**UNITED STATES
NUCLEAR REGULATORY COMMISSION**
WASHINGTON, D.C. 20555-0001

**SUBJECT: H. B. ROBINSON STEAM ELECTRIC PLANT, UNIT NO. 2 – ISSUANCE
OF AMENDMENT NO. 260 REGARDING REQUEST TO REVISE TECHNICAL
SPECIFICATION REACTOR COOLANT SYSTEM PRESSURE AND
TEMPERATURE LIMITS TO REFLECT 24-MONTH FUEL CYCLES
(EPID L-2017-LLA-0033)**

SAFETY EVALUATION BY THE OFFICE OF NUCLEAR REACTOR REGULATION

Figure 3.4.3-1
Reactor Coolant System Heatup Limits
Applicable Up to 46.3 EFPY

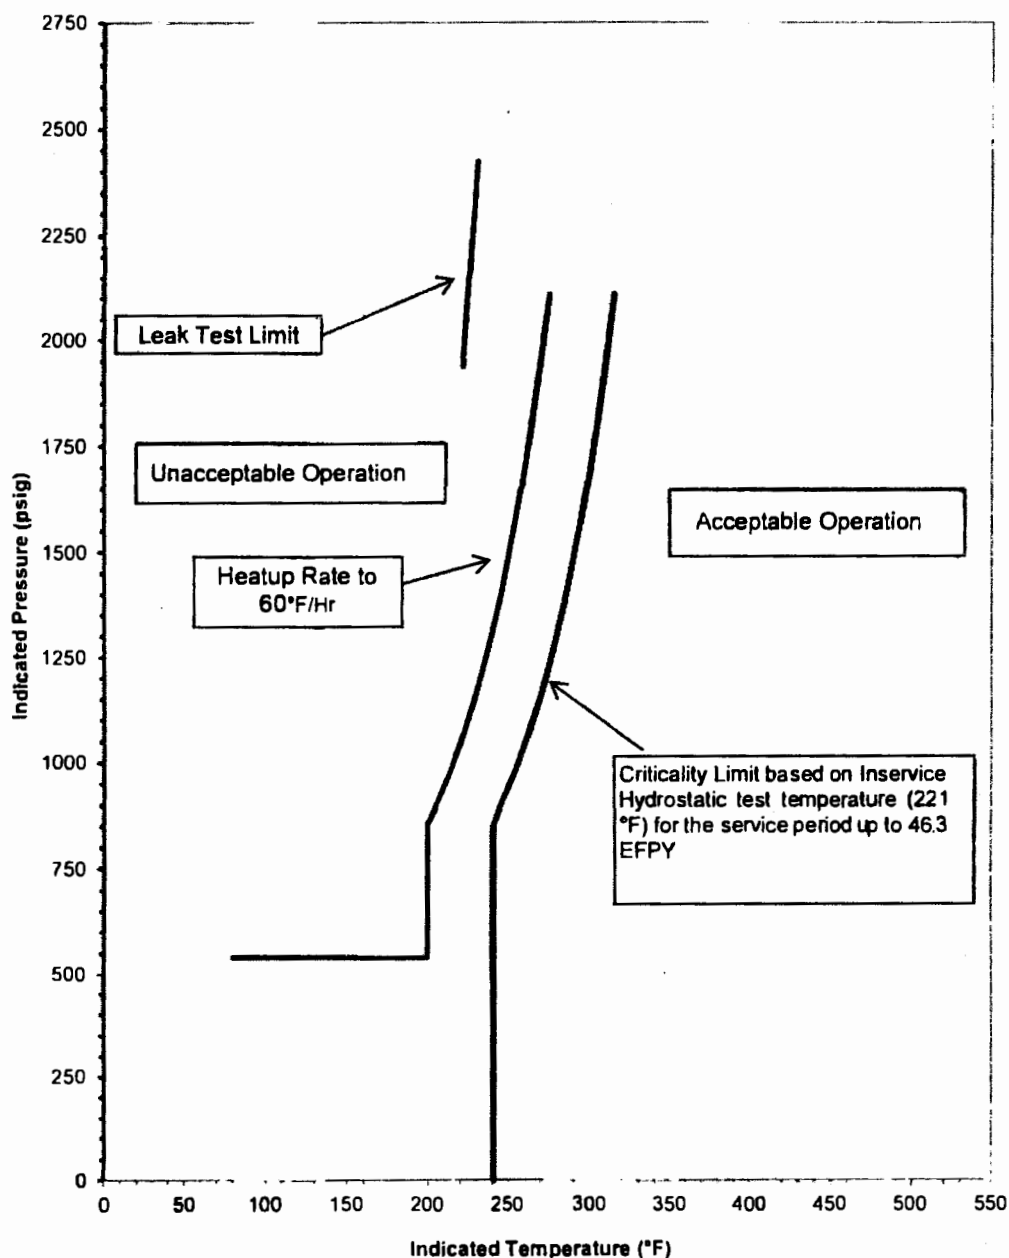
The amendment revises TS Section 3.4.3 "RCS [Reactor Coolant System] Pressure and Temperature (P/T) Limits," to reduce the applicability terms from 50 effective full-power years to 46.3 effective full-power years in Figures 3.4.3-1 and 3.4.3-2, as a result of the removal of part-length fuel assemblies and the migration to 24-month fuel cycles.

The licensee proposes to change the applicability of the HBRSEP P/T limits from 50 EFPY to 46.3 EFPY as a result of removal of PLSAs and migration of the facility to a 24-month fuel cycle from an 18-month fuel cycle. The licensee presented its technical basis for this change in WCAP-18215-NP (included as Attachment 2 of the LAR). Removal of PLSAs and migration to a 24-month fuel cycle increase neutron fluence, and therefore, the degree of embrittlement of the RPV materials used in determining P/T limits.

Curves applicable for heatup rates up to 60°F/Hr for service period up to 46.3 EFPY
